## National Fire Protection Association

### MEMORANDUM

**TO:** NFPA Technical Committee on Liquefied Natural Gas  
**FROM:** Elena Carroll, Administrator, Technical Projects  
**DATE:** May 9, 2011  
**SUBJECT:** NFPA 59A ROC TC Letter Ballot (F2011)

Modify Figure 15.9.2 as shown:

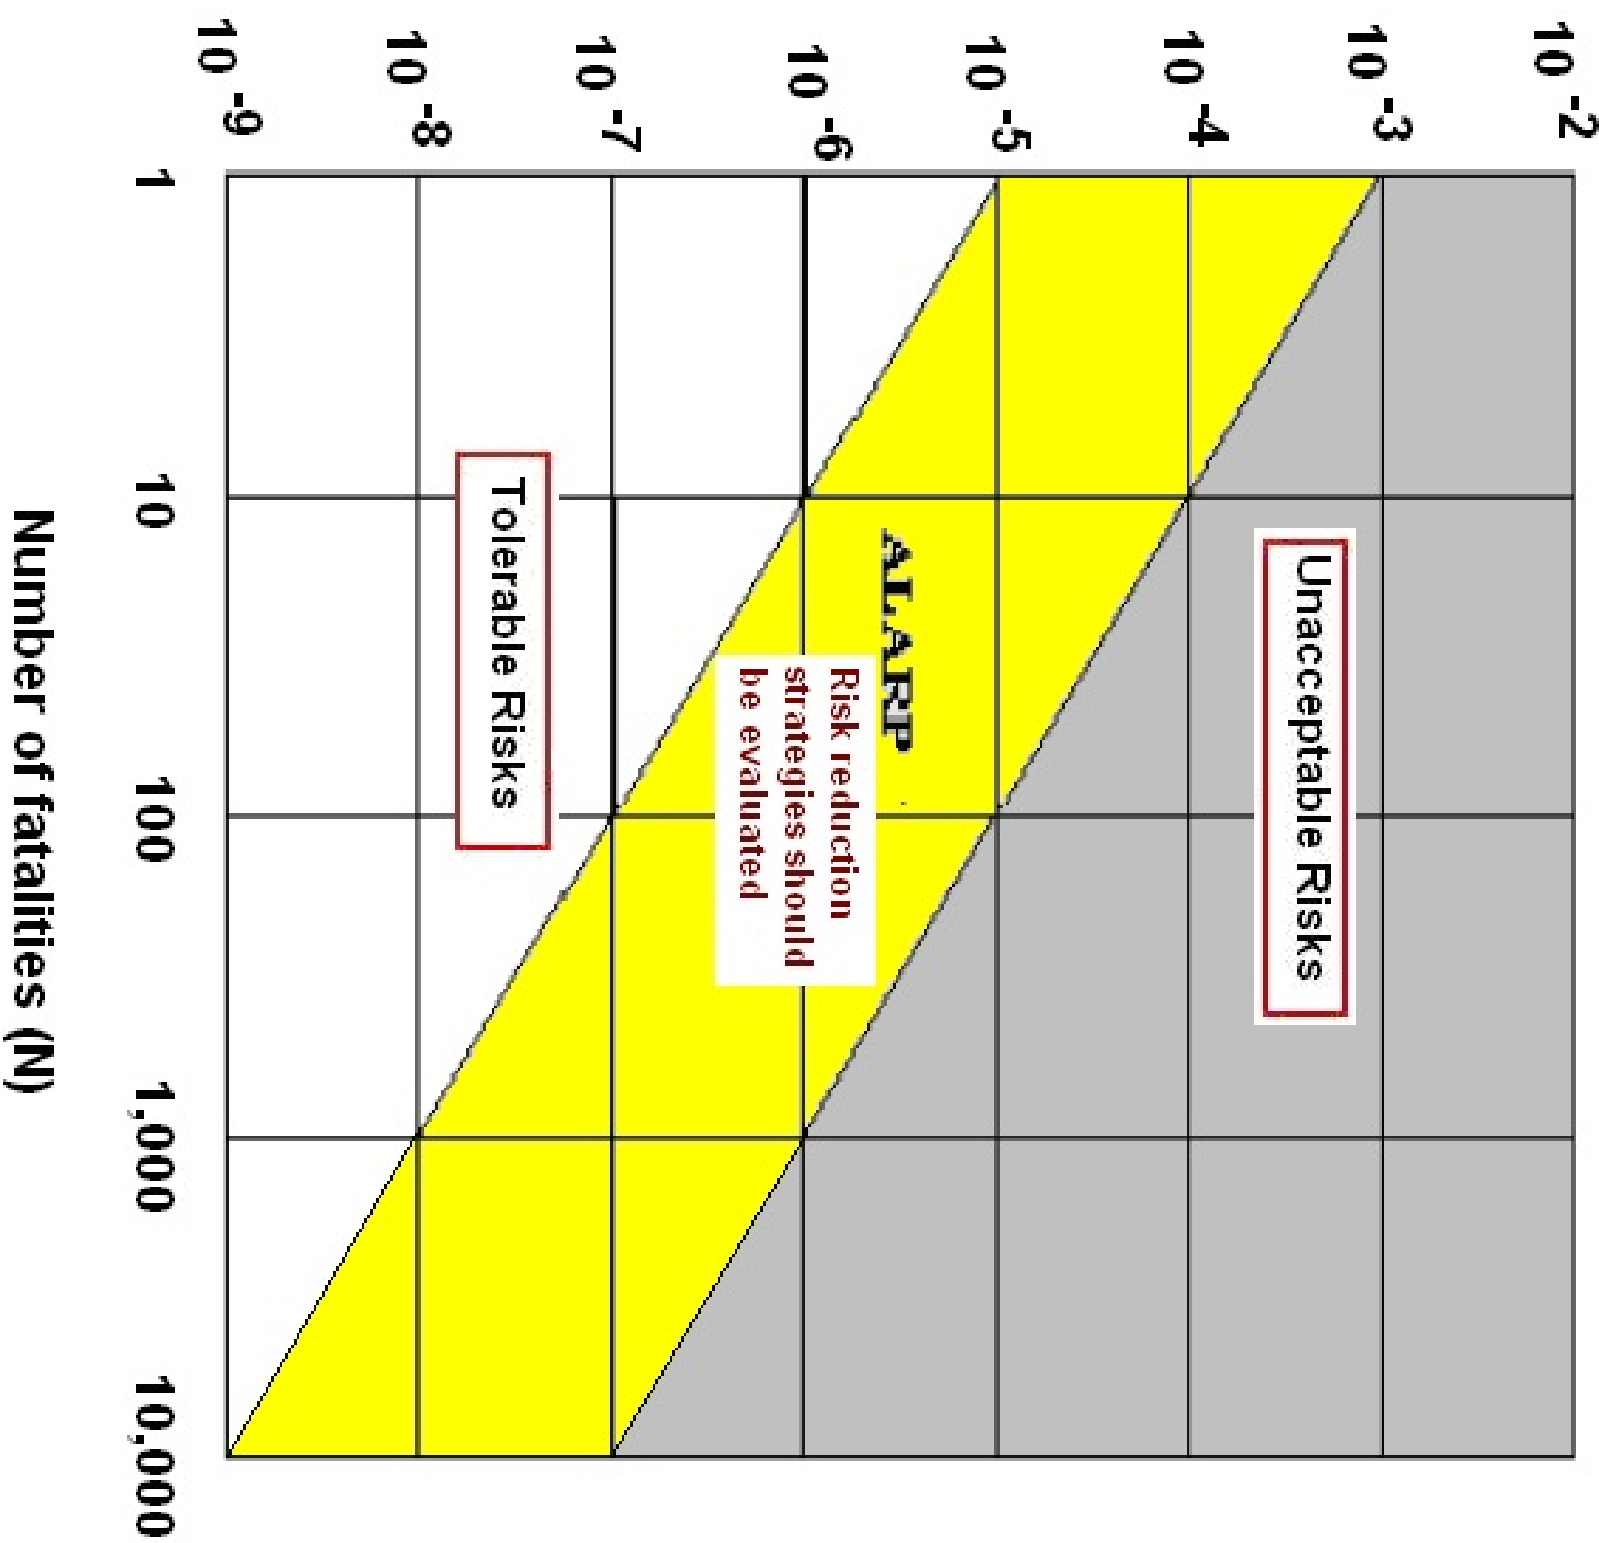
Change column 1 title in Table 15.9.1 as follows: Criterion Annual ~~Probability~~ Frequency

Change the title of Table 15.9.2 as follows: Table 15.9.2: Criteria for tolerability of Societal (~~injury~~fatalities) Risks.

Change column 1 title in Table 15.9.2 as follows: Criterion Annual ~~Probability~~ Frequency

Change note to Table 15.9.2 as follows: (F= Annual probability of experiencing N or more ~~injuries~~ fatalities)

**Committee Statement:** The committee reviewed and revised the proposed definitions that were overlooked in the publishing of the ROP. The definitions were placed in a section in chapter 15 to insure that some terms that are used elsewhere in the standard, such as "event", could be defined specifically for the context of chapter 15. The definitions were revised to reflect input from multiple sources on risk assessment. The figure was revised to extend the ALARP region at the same slope because limiting the ALARP region would unnecessarily restrict the siting of plants where additional mitigation measures could be taken. Annex material was added to several paragraphs to provide additional guidance and background for users.
